Re: Petition No. 1484 – Modifications to Gales Ferry Substation

Responses to CSC-01 Interrogatories, dated February 22, 2022
CSC-01 through CSC-013.

**Gales Ferry Substation Expansion Project
Distances to Abutting Properties**

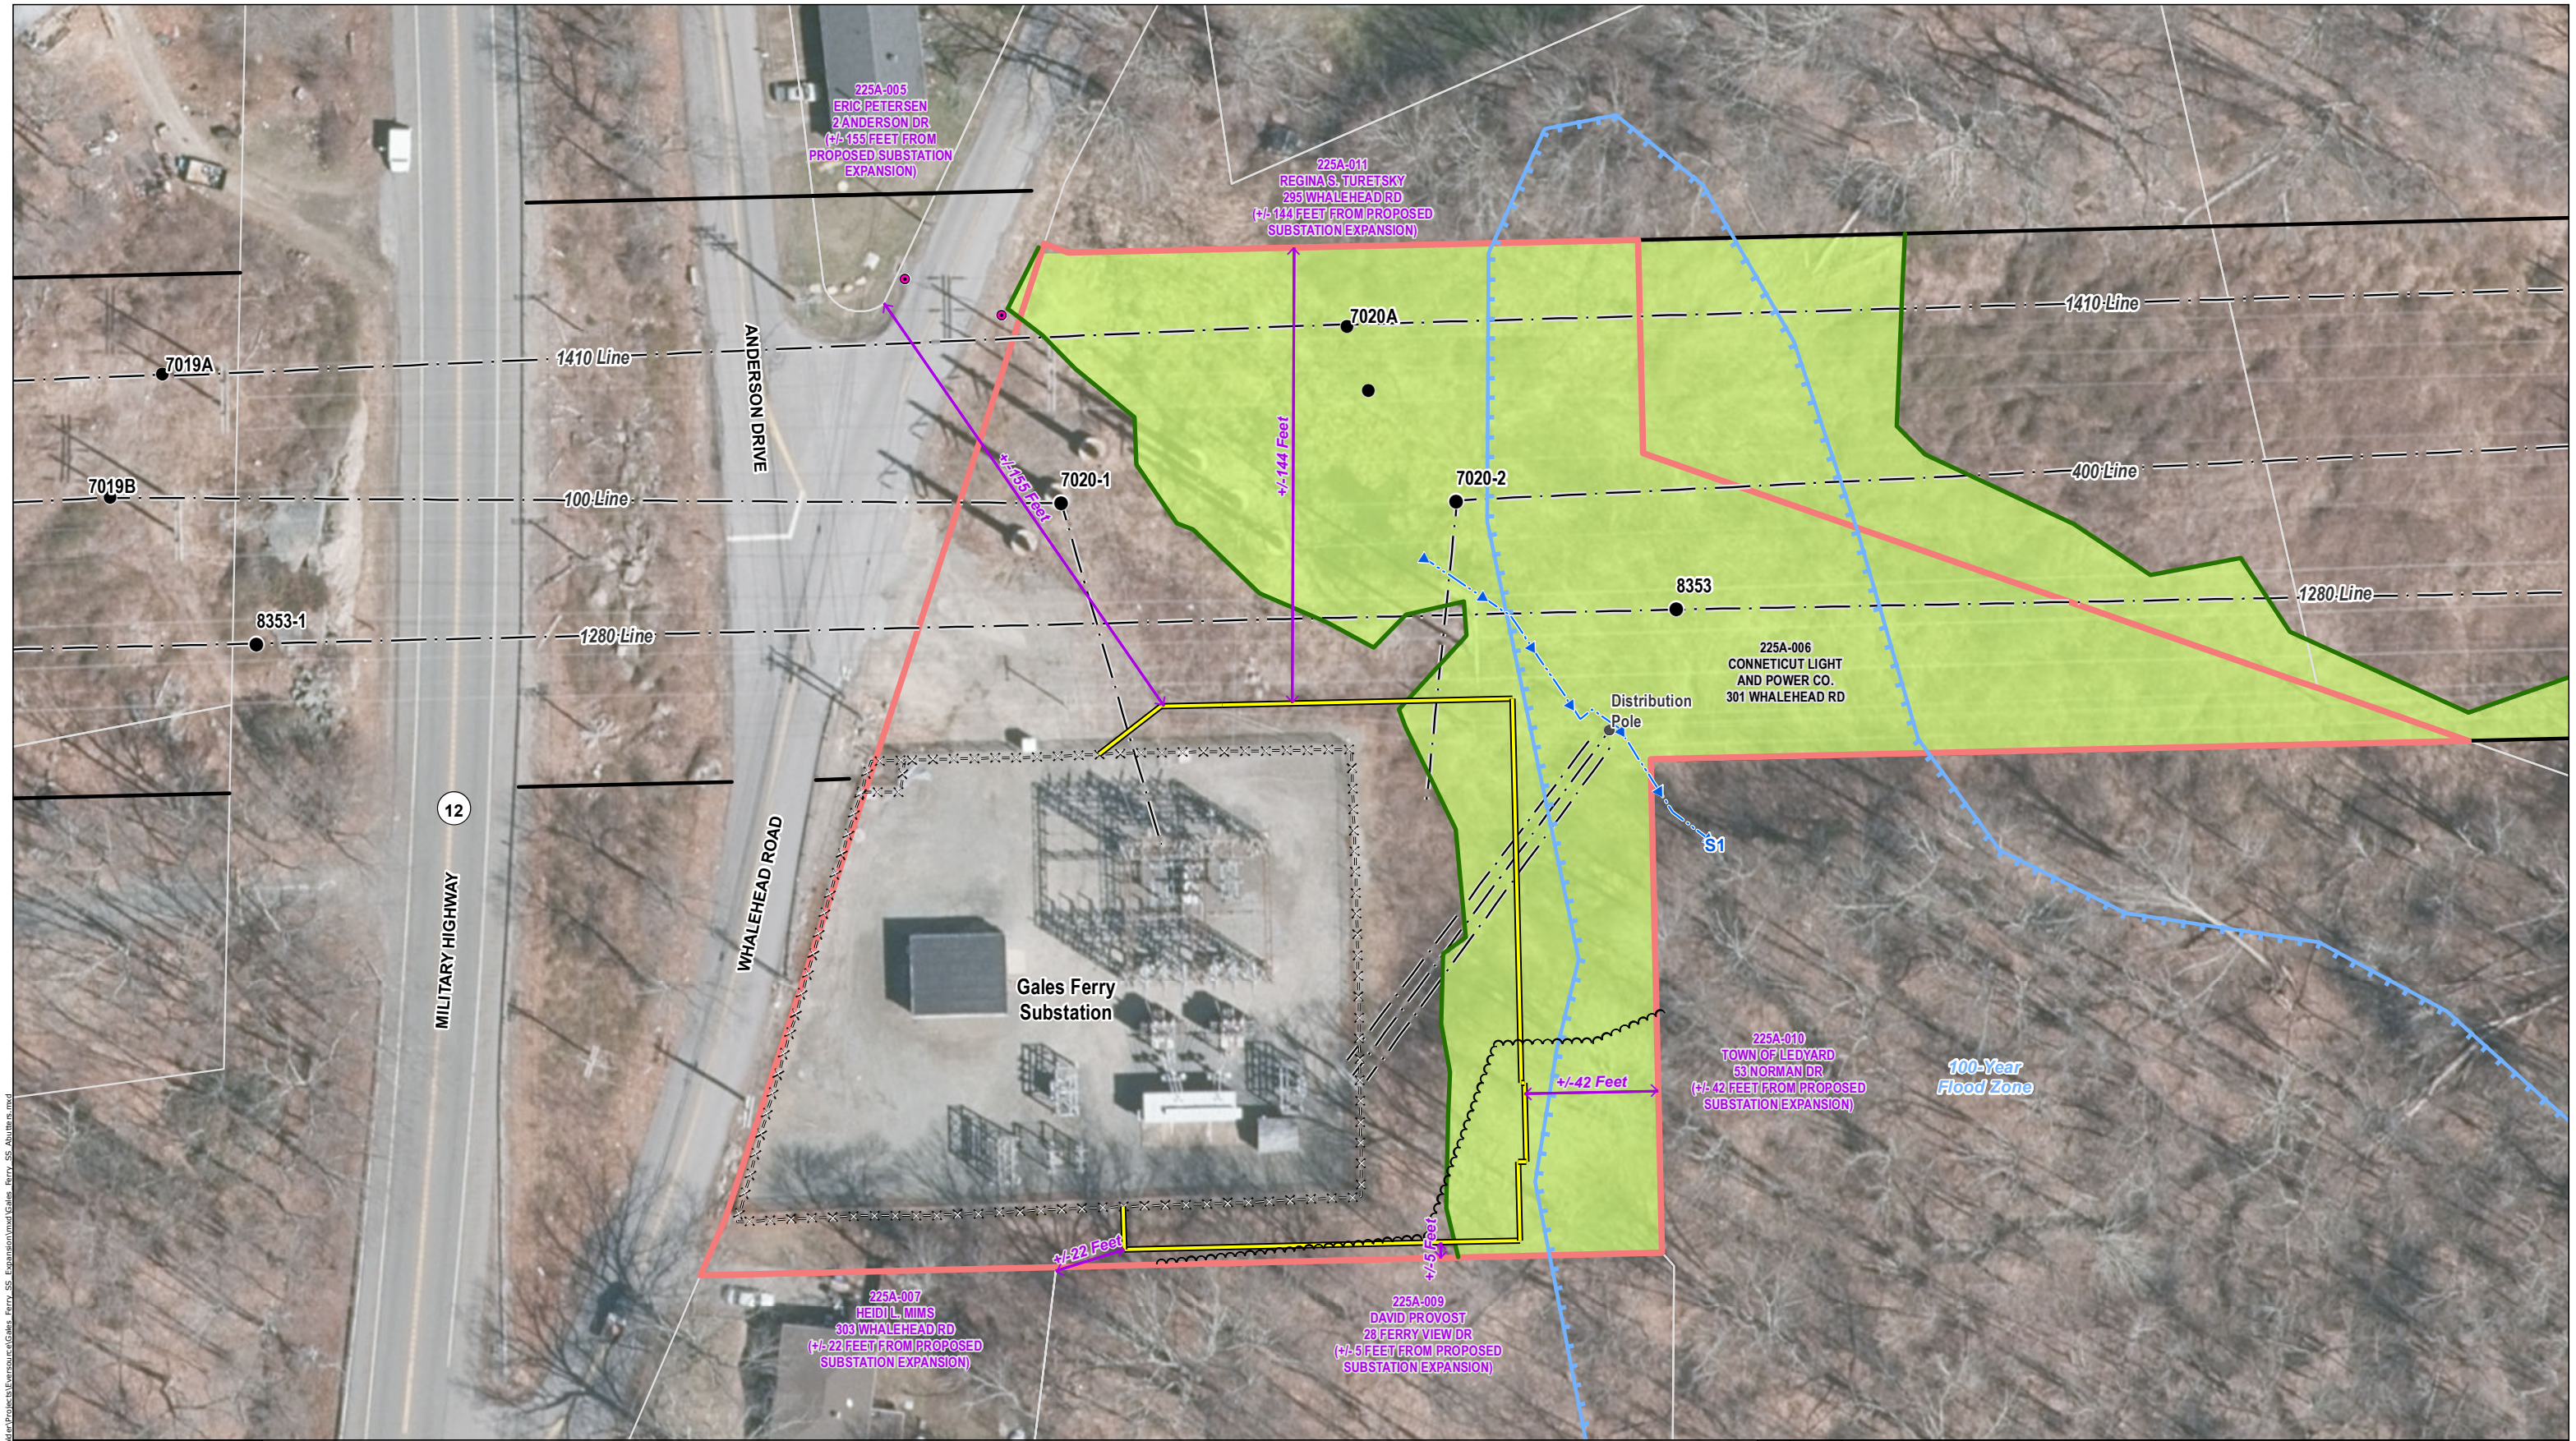
Provide a drawing with distances from the re-designed substation to abutting properties

A drawing with distances from the re-designed substation to abutting properties is attached.

**Gales Ferry Substation Expansion Project
Existing Conditions**

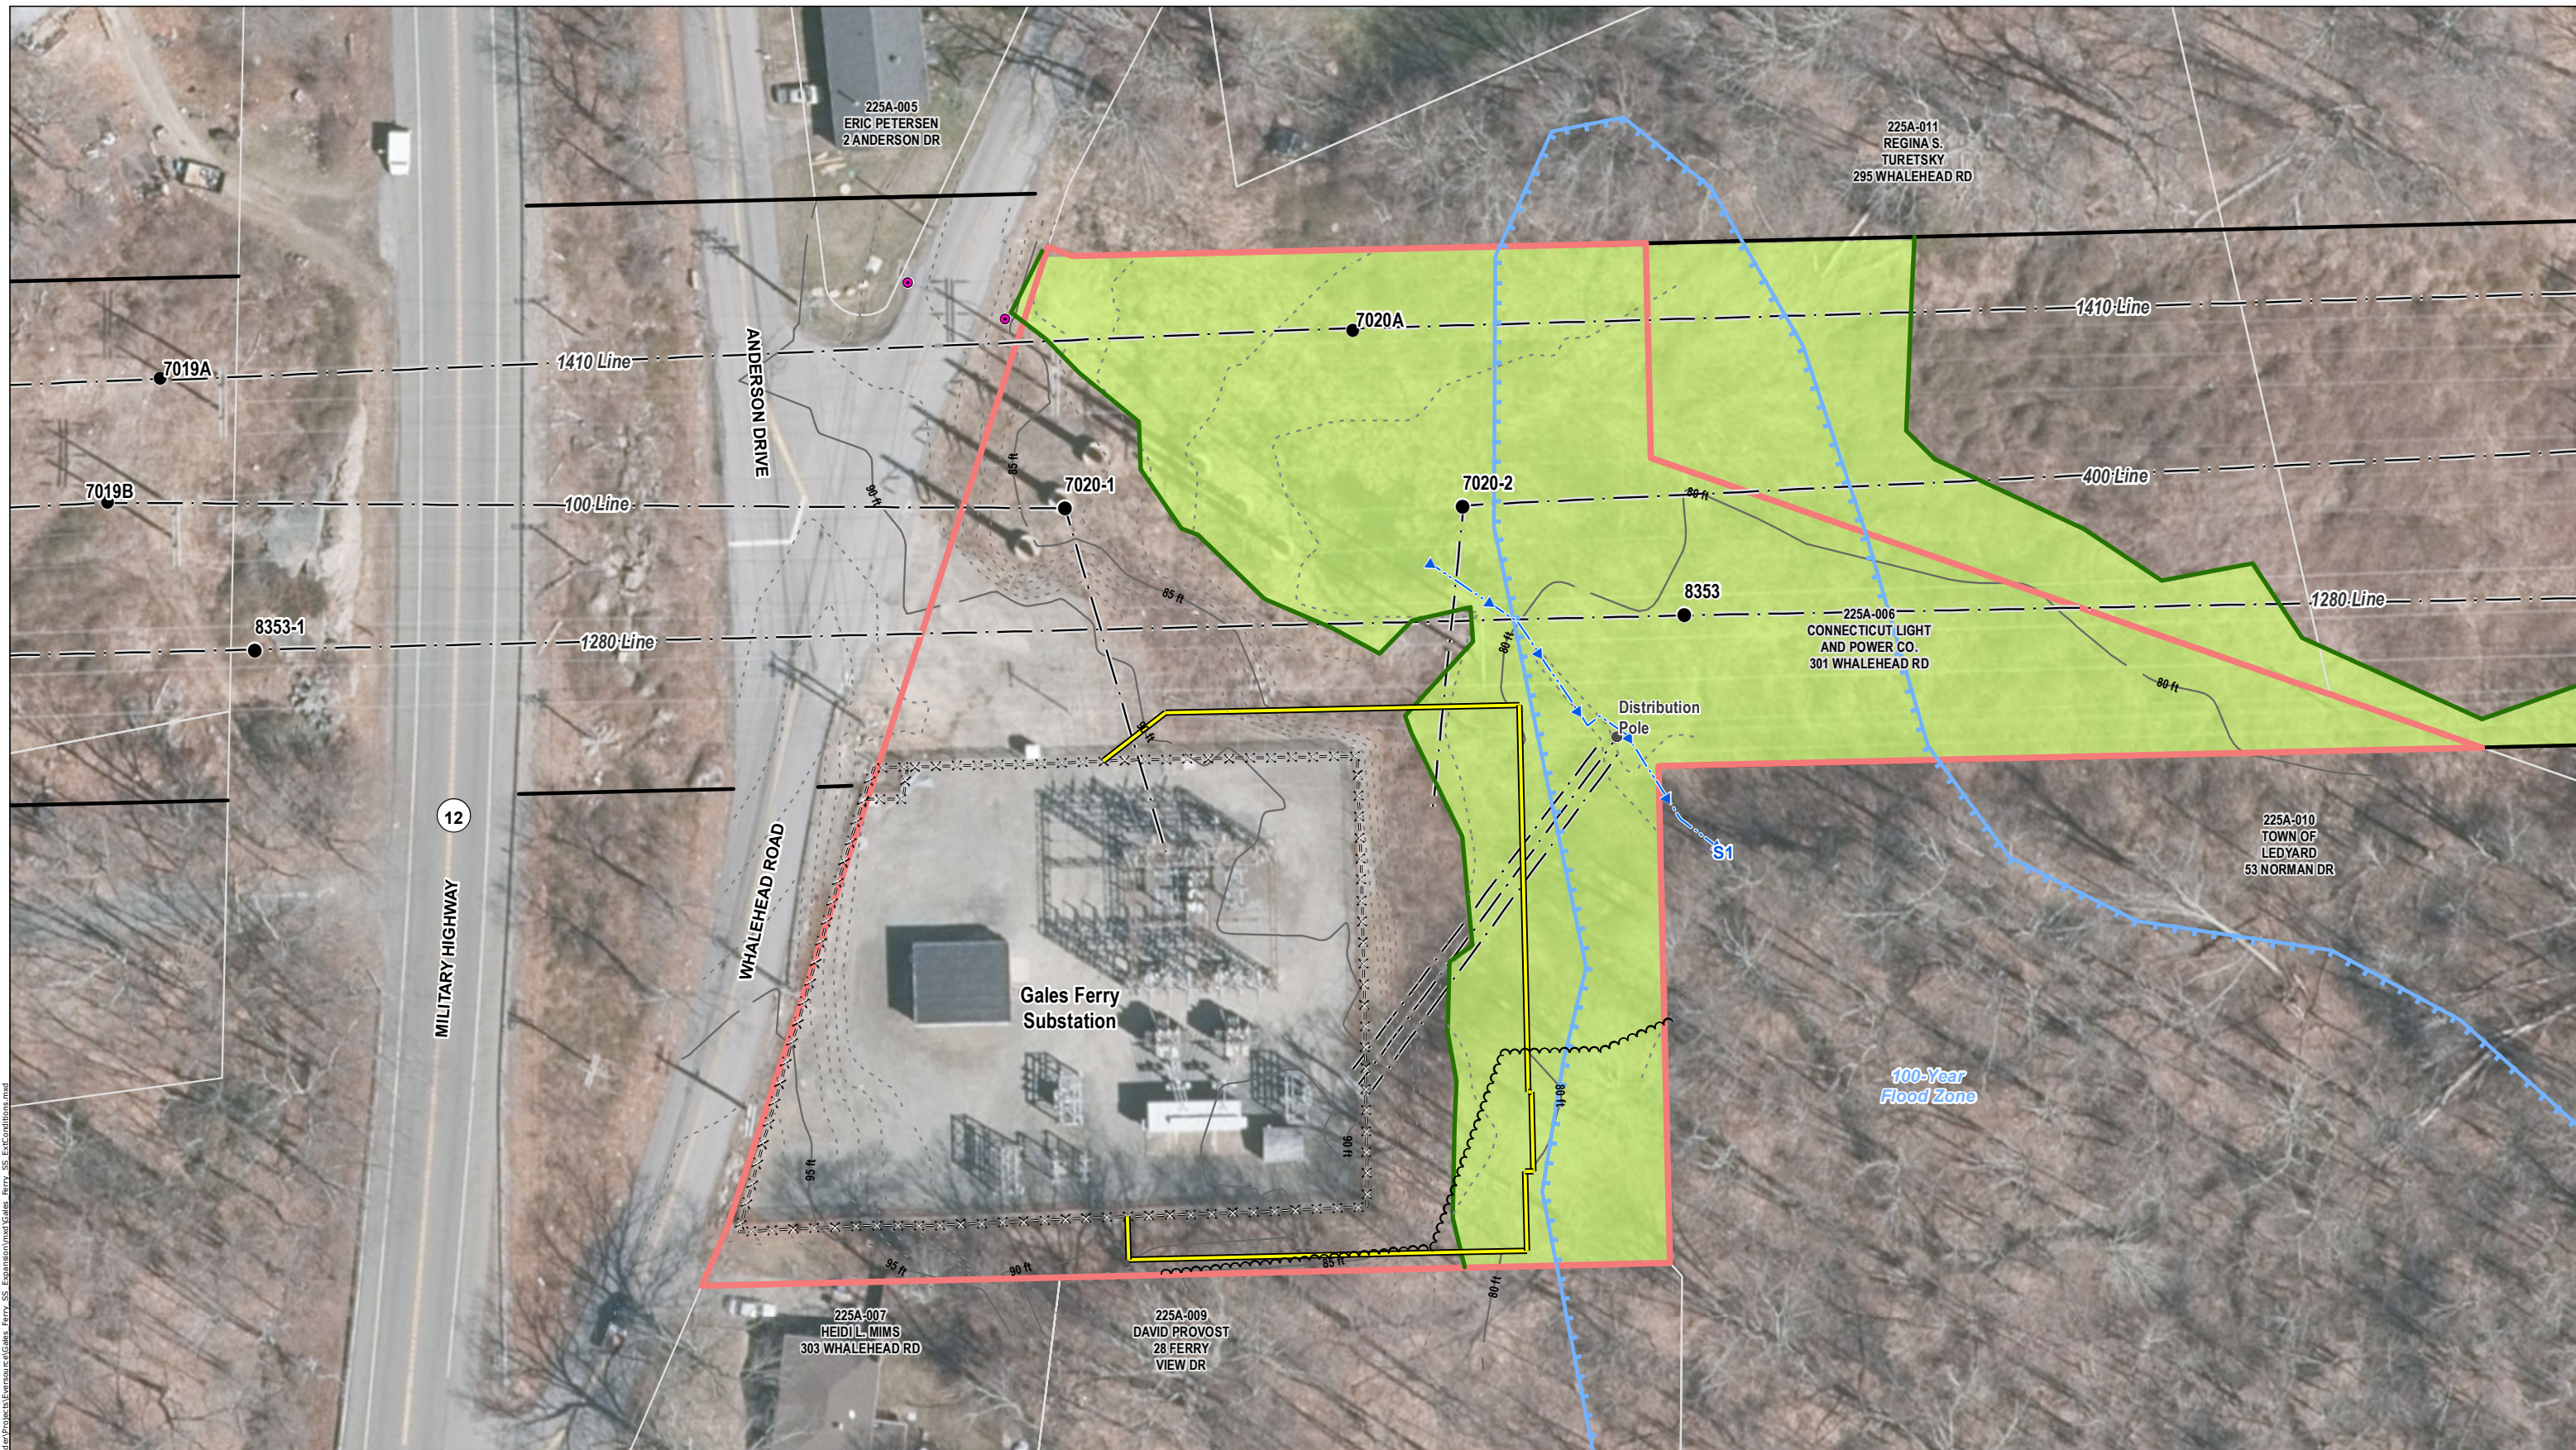
Provide an aerial photograph of existing conditions with a line denoting the expansion area.

An aerial photograph of existing conditions with a line denoting the expansion area is attached. Note that the structures shown on the plan are part of the scope of work approved by the Council in Petition No. 1475 and is expected to be representative of existing conditions at the time the construction under this petition is initiated.
